## 2018 Scalpel SE 2

### Down Tube Clearance , Fox Performance 34 Fork

#### Required Lower Headset Cup & Crown Race

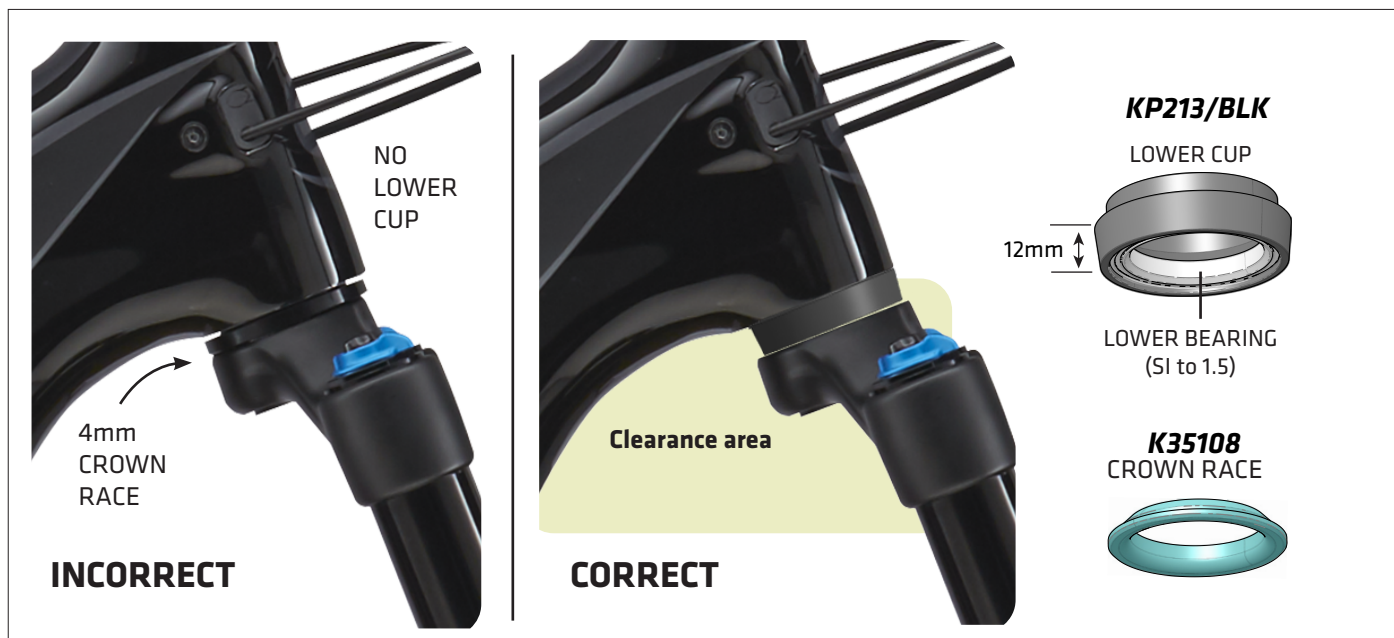
- 2018 Scalpel SE 2 sizes S, L and XL with the Fox Performance 34 fork require lower headset cup **KP213/BLK** and crown race **K35108**. These parts are not required on M size frames.
- KP213/BLK** is a 12mm height cup which provides the additional and necessary down tube clearance between the Fox Performance 34 fork adjusters and the down tube.

Additional clearance is needed on S, L and XL frame sizes to prevent the fork adjusters from striking the frame when the handlebars are turned.
- If 2018 Scalpel SE 2 sizes, S, L, and XL does not have the **KP213/BLK** lower cup and **K35108** crown race installed already, the parts must be installed by a Cannondale Dealer according to the service instructions.
- At this time, KP213/BLK and K35108 are only indicated for use with 2018 Scalpel SE 2 sizes S, L, and XL and the Fox Performance 34 fork. These parts should not be used on other 2018 models.

- To install these parts, the SI bearing should be removed from the lower head tube. It is to be re-used.

The lower bearing must be pressed into the **KP213/BLK** cup first. Be sure to apply light grease to the bearing and the cup when using ([Park Tool: HHP-2](#)). Use the correct headset adapters when pressing the cup/bearing combination into the head tube.

The existing 4mm crown race must be removed from the fork using ([Park Tool:CRP-2](#)) and crown race **K35108** installed using ([Park Tool: CRS-15.2](#)) in its place.
